DOWNTOWN MASTER PLAN CODE AMENDMENTS

STAKEHOLDER OUTREACH MEETINGS AND PUBLIC COMMENTS SUMMARY

Station 1. BUILDING FLOORPLATE & TOWER SEPARATION

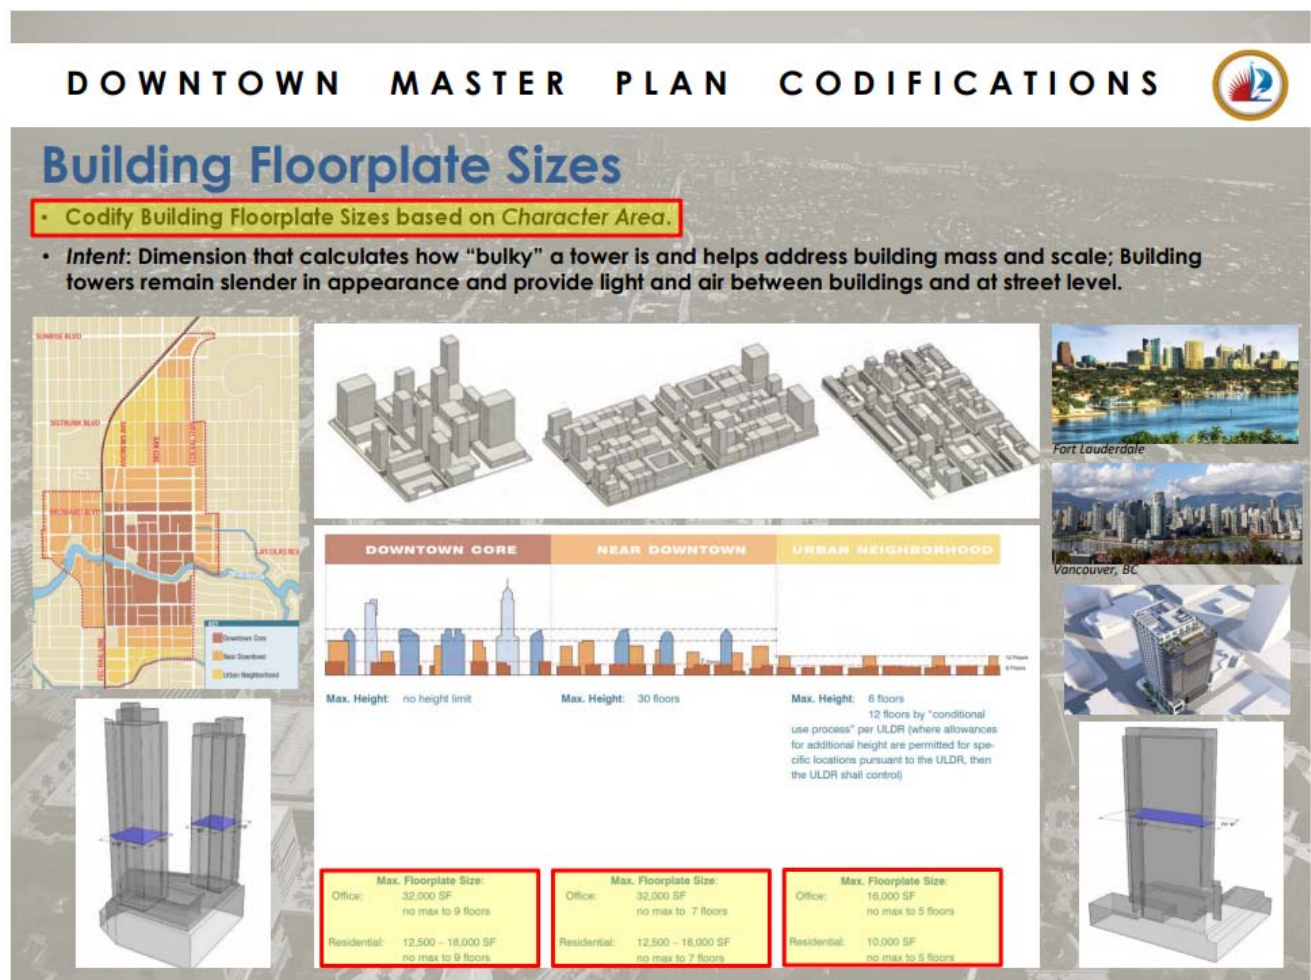
- Allow for average floorplate for towers, when projects have varying floorplates or building is uniquely designed. [7]
- Maintain existing character area boundaries, floorplates and shoulder height limits. [2]
- There should be flexibility for projects that propose unique design, sustainable design, or allow for deviation. [8]
- Creative ground level design should allow for larger floorplates in exchange. [5]

Station 3. PODIUM HEIGHT & STEPBACKS

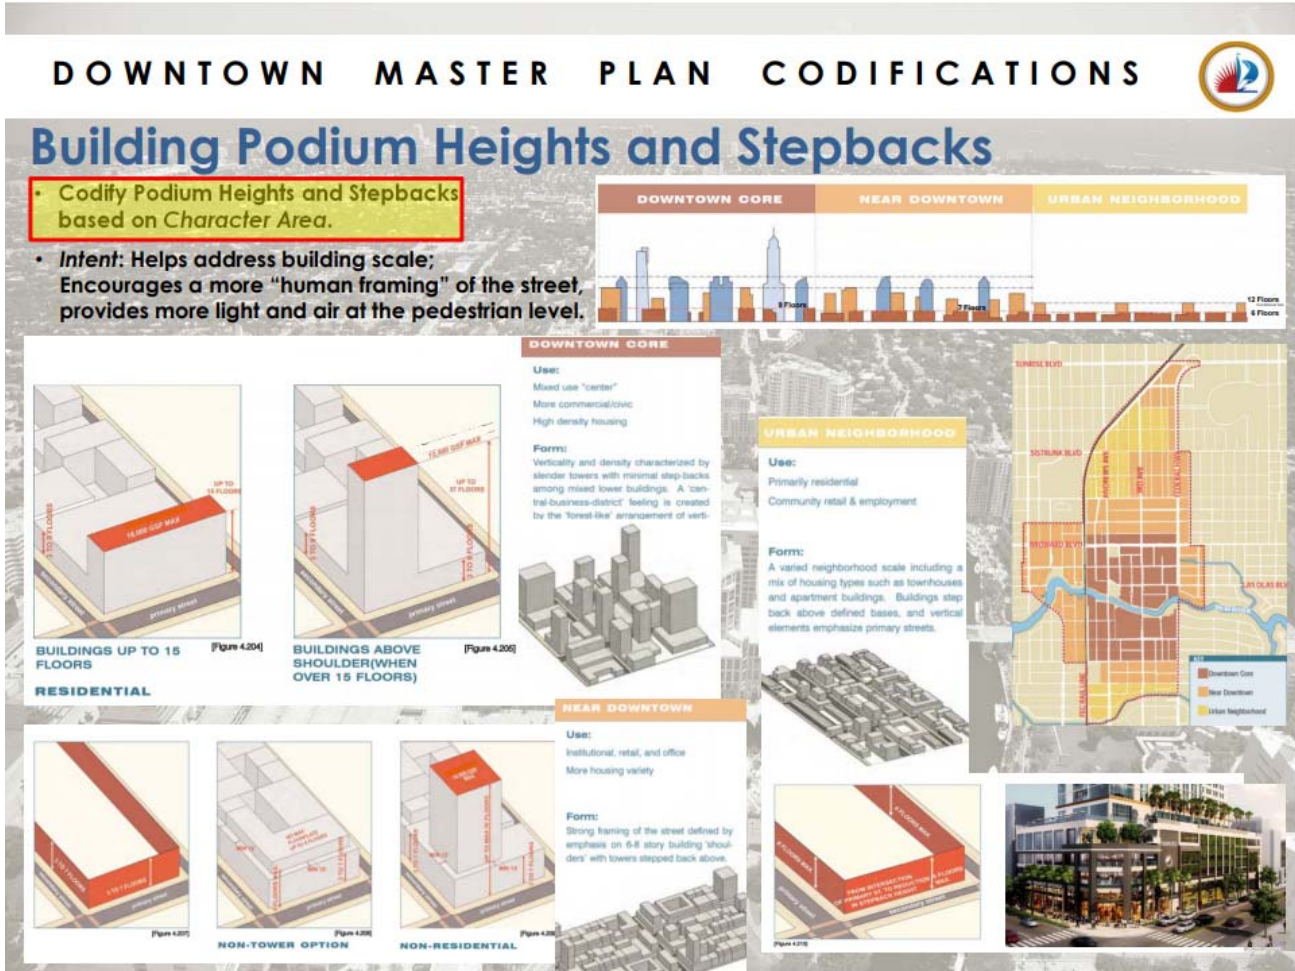
- RAC-RPO - moving to RAC-SMU; Character area from SW 9th to 20th Street - Shift character areas.
- Straighten random turns in character areas, Ex. NE from downtown at Sistrunk; Continue near Downtown from US 1 and track along Sistrunk; Makes for a smoother transition. [3]
- Can a developer get points for being next to a park?
- Character areas - Is that a consideration?
- 30 stories is too high in transitional areas; Need to drop when on line with neighborhood. [8]
- There is no details on the graphics regarding total height, what is it? How high is a floor? ULDR plan needs to have clarity.
- What about architectural excellence? Requirement skyline drama, design. How is that reviewed and required? Prescriptive? [7]
- Is there an opportunity to require reasonable/affordable housing? Fee simple vs. rental. [3]
- Alternate design on podium heights on step backs should be permitted.

Open Space

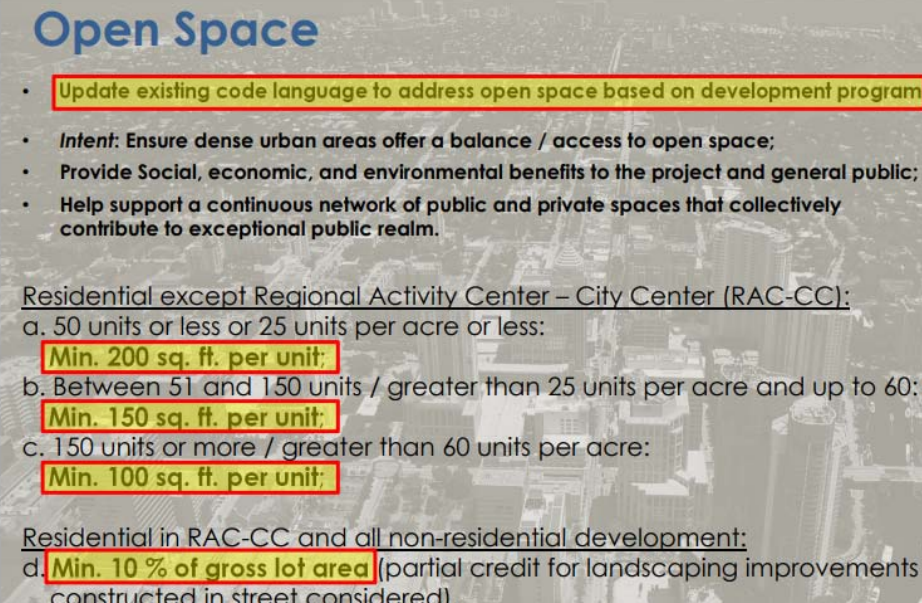
- City should provide open space to urban core; How would street trees be counted in landscape requirements? [4]
- Allow flexibility for tree lines not buildings. [1]

- Consistent sidewalk section/prioritize from block to block.
- Create off-site mitigation credit.
- Looks like a concrete jungle is being built along US1 north of tunnel. [4]

- Each street should be treated individually. [3]
- Landscape regulation not realistic. [1]
- Higher density should imply higher (not lower) landscape requirement. [8]

- Allow for flexibility and review of conditions on a case by case basis. [1]
- Downtown core needs one-way street pairs. [2]
- Can a developer use/get points for being next to a park? Is it considered?

- Need to take special care of tower radius on all downtown coverage for "typical" trucks to turn; Either wider turns or limited size of the trucks by ordinance or special permit. [3]

- Lack of green landscaping between buildings & street.
- Demand building built further from sidewalk. [2]
- Consider created "superblocks" (e.g. Barcelona) - lower traffic & increase walkability and consolidate open/green space. [1]

- Wider sidewalks. [2]
- Get rid of on street parking and provide bike lanes. [2]
- More regulations to make downtown more walkable (TOD).
- Open space for non-resident development should be more than 10%.
